RE: Ogilvy River Farm Pit (Permit No. M-2024-006)
Adequacy Review #1

Ogilvy River Farm, LLC has received the Division's Adequacy Review #1 letter dated April 26, 2024. Below are the comments and the corresponding responses that we have provided to address the comments.

Project Ogilvy River Farm
Slope Stability - Case SS-3 Mining Slope - Static - With Bearing - to Road

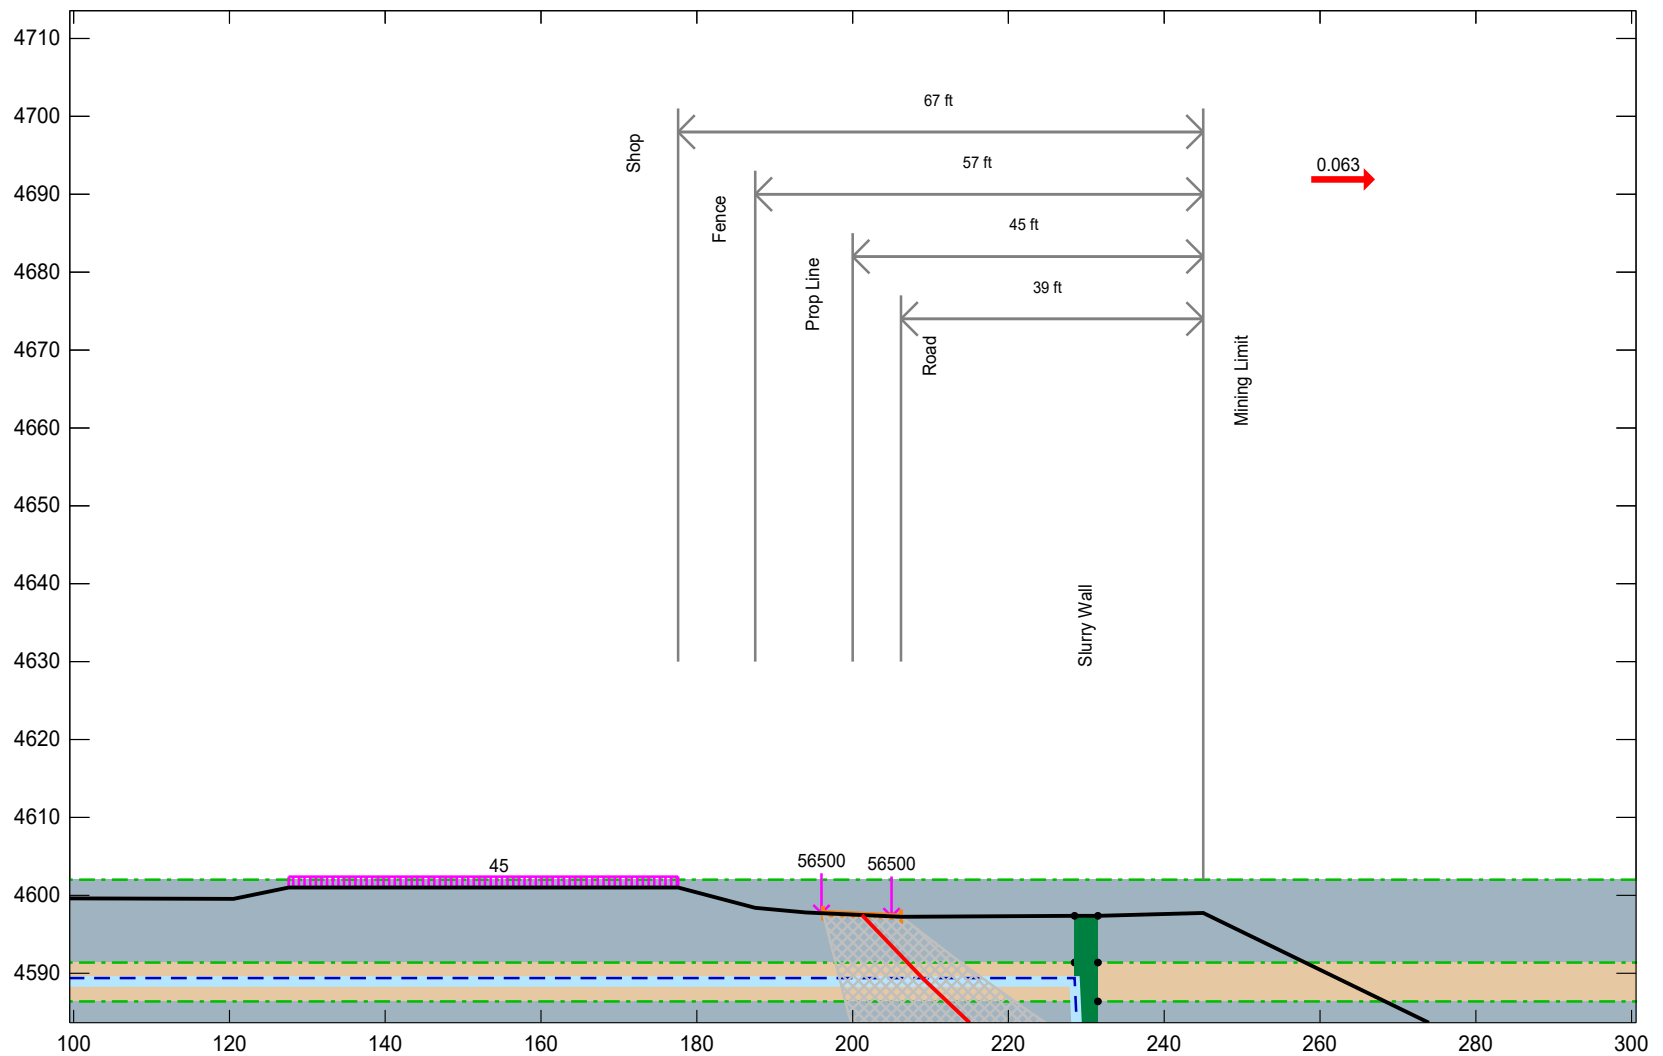
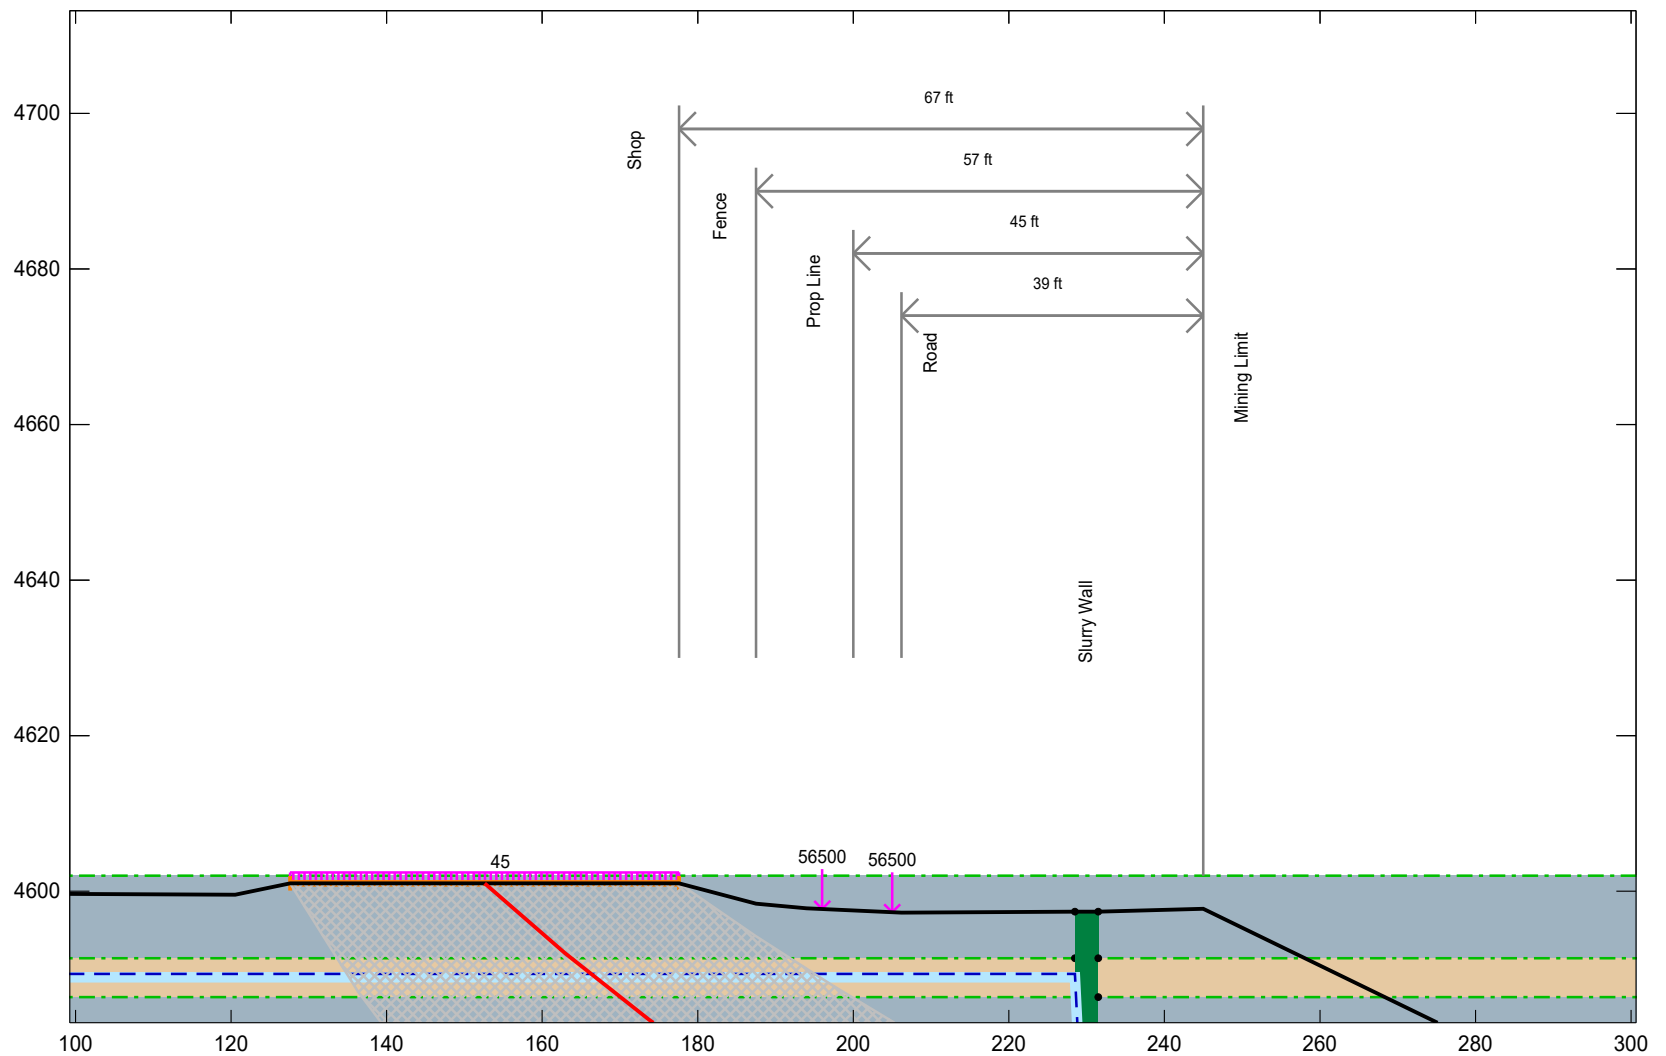
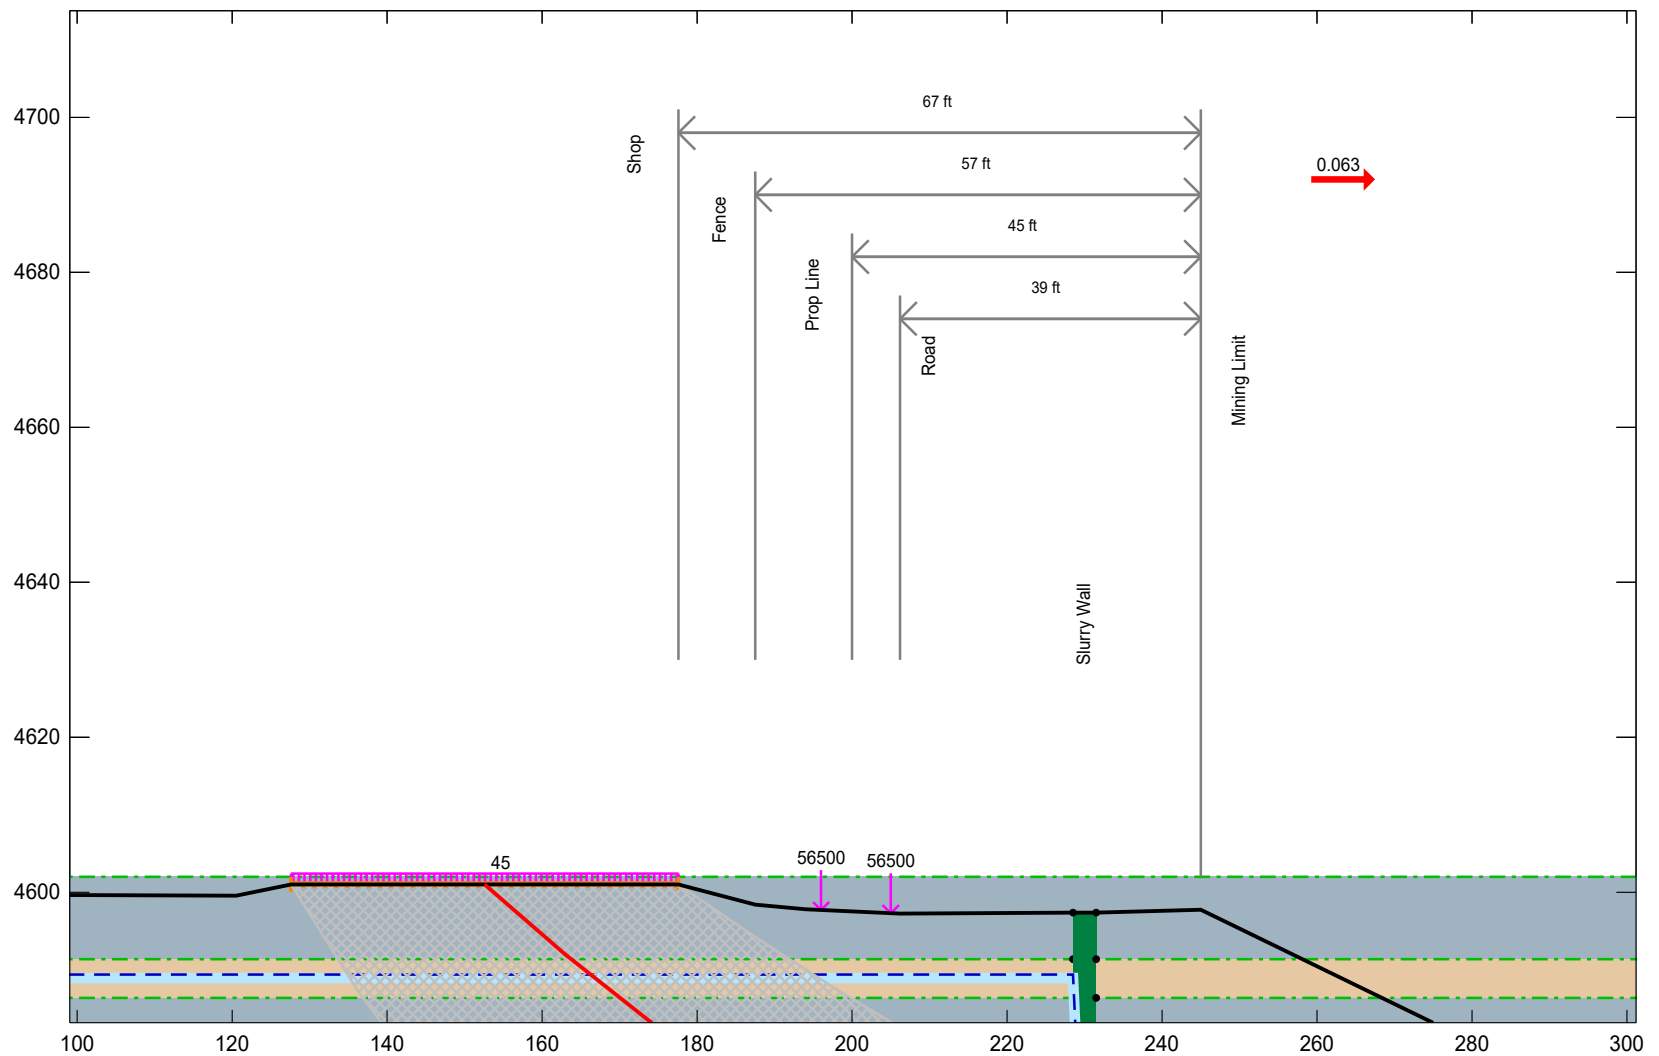
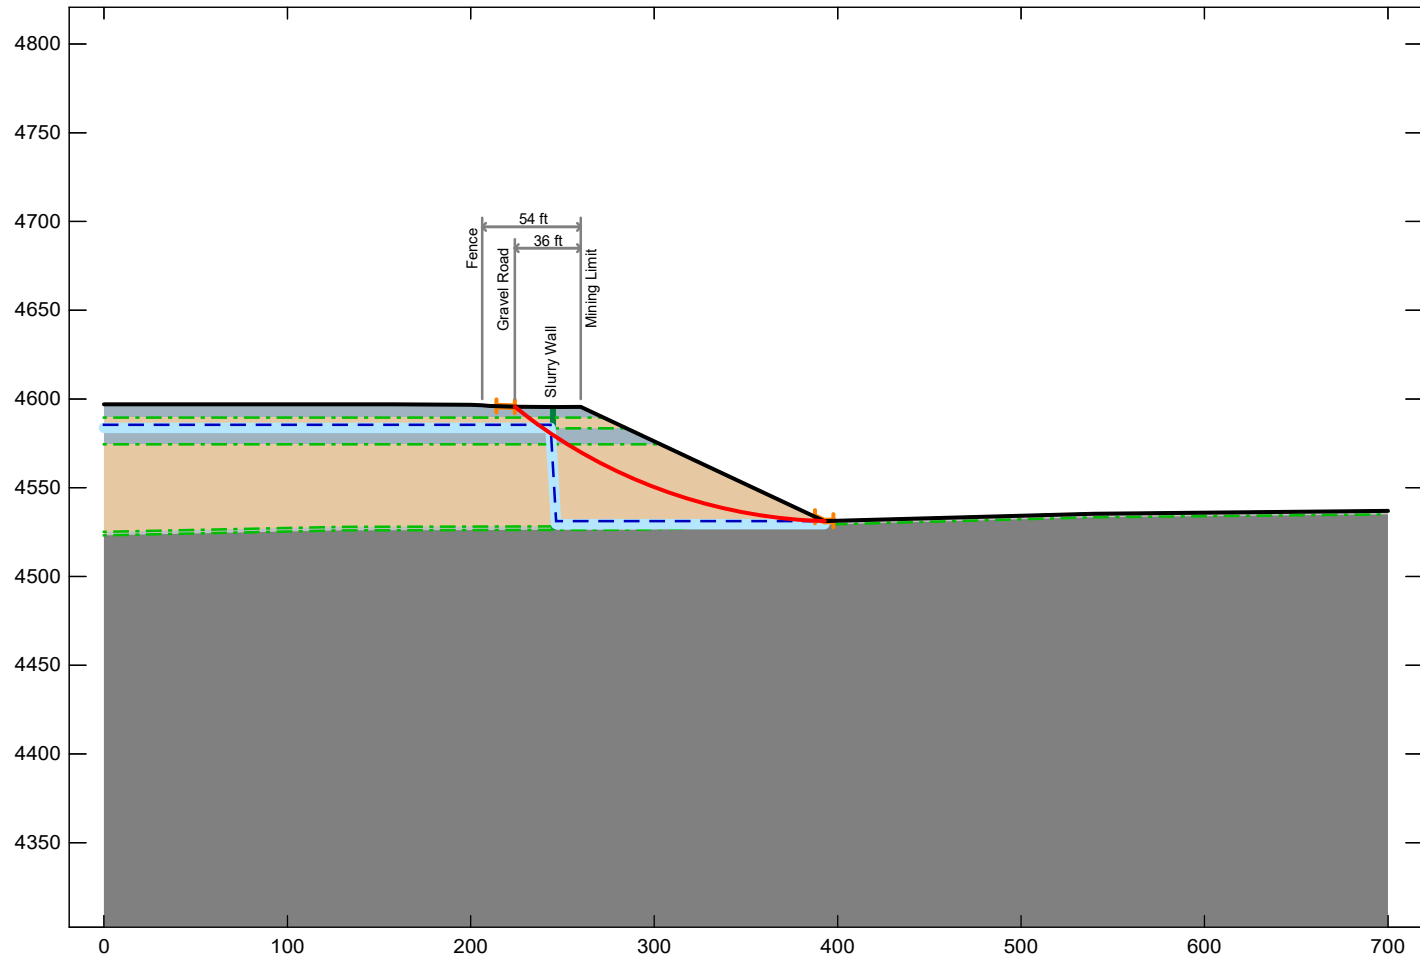
18. A setback of 39 feet from the mining limit to the gravel road was demonstrated as meeting the MLRB requirements for Case SS-3. Can you clarify the distance from the mining limit to the fence line?

Response: Yes, the distance from the mining limit to the fence line is 57 feet.

Project Ogilvy River Farm
Slope Stability - Case SS-4 Mining Slope - Static

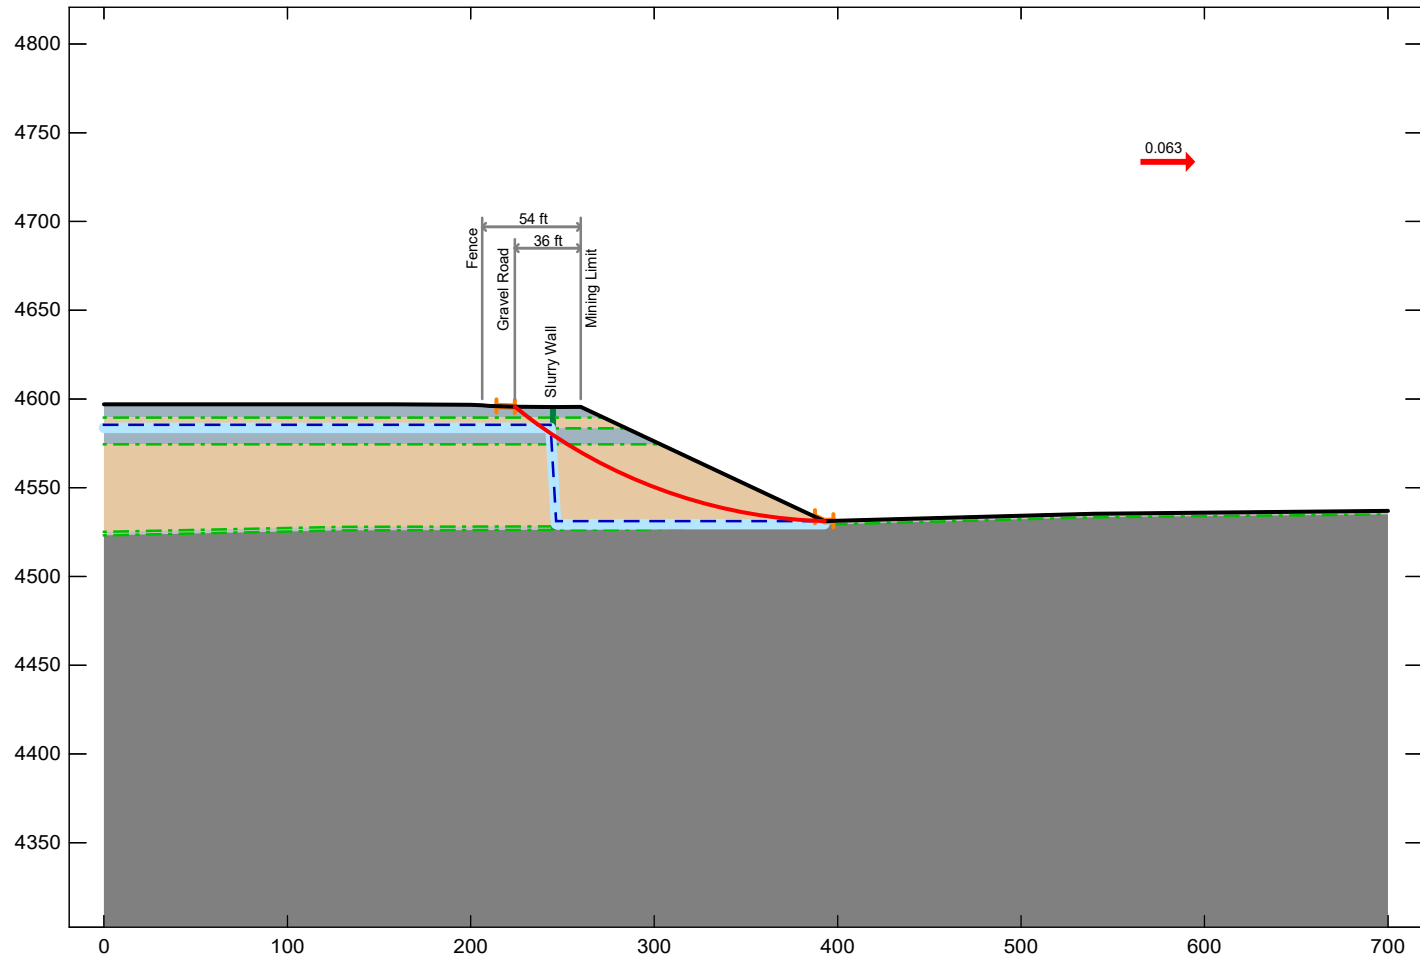
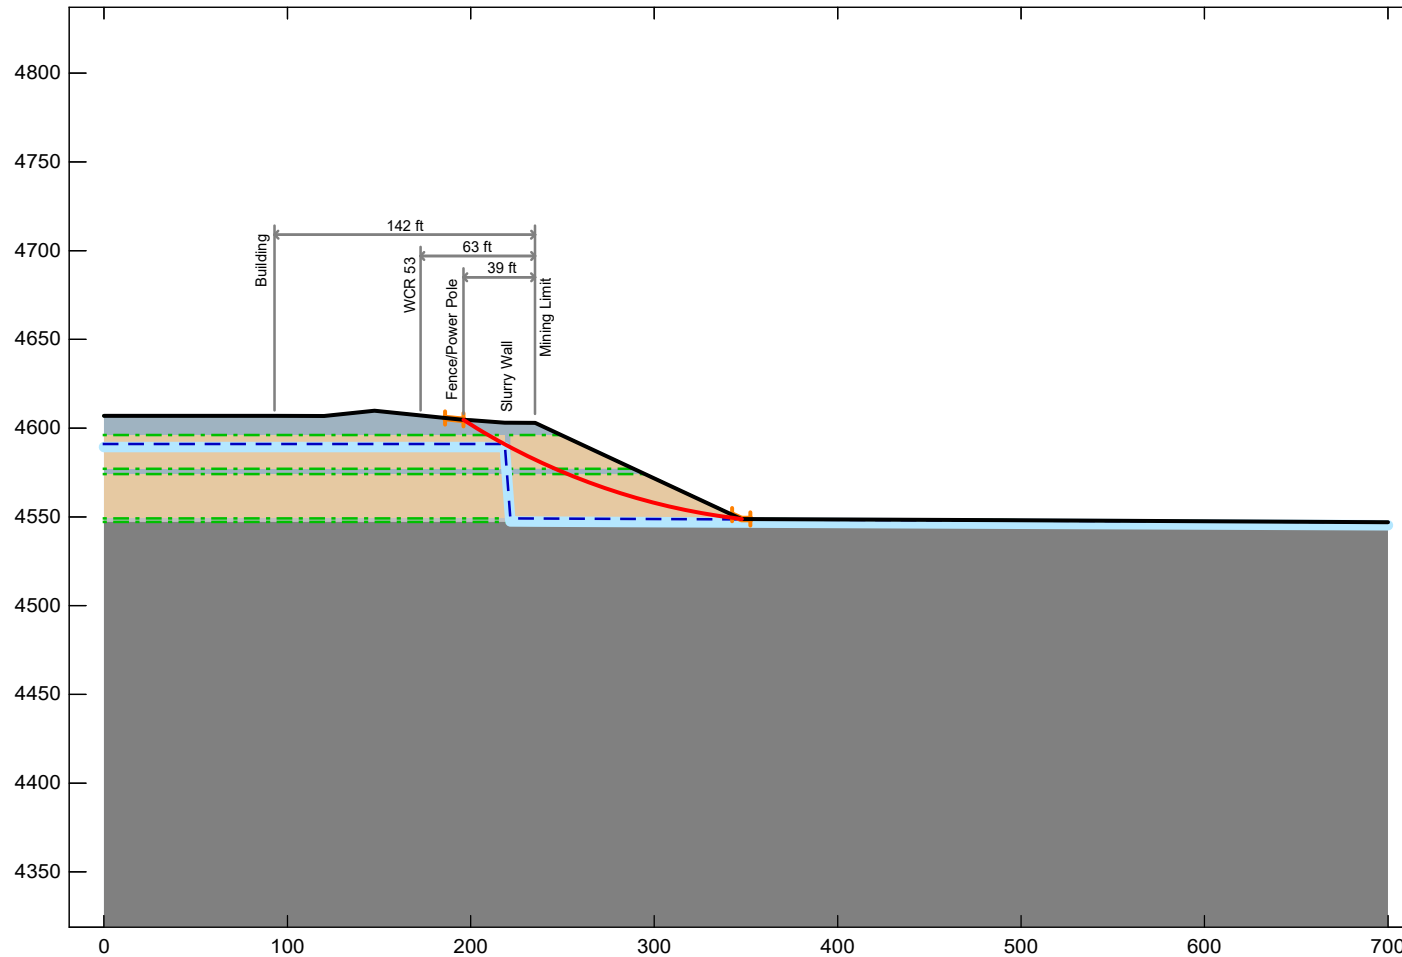
19. A setback of 36 feet from the mining limit to the gravel road was demonstrated as meeting the MLRB requirements for Case SS-4. Can you clarify the distance from the mining limit to the fence line?

Response: Yes, the distance from the mining limit to the fence line is 54 feet.
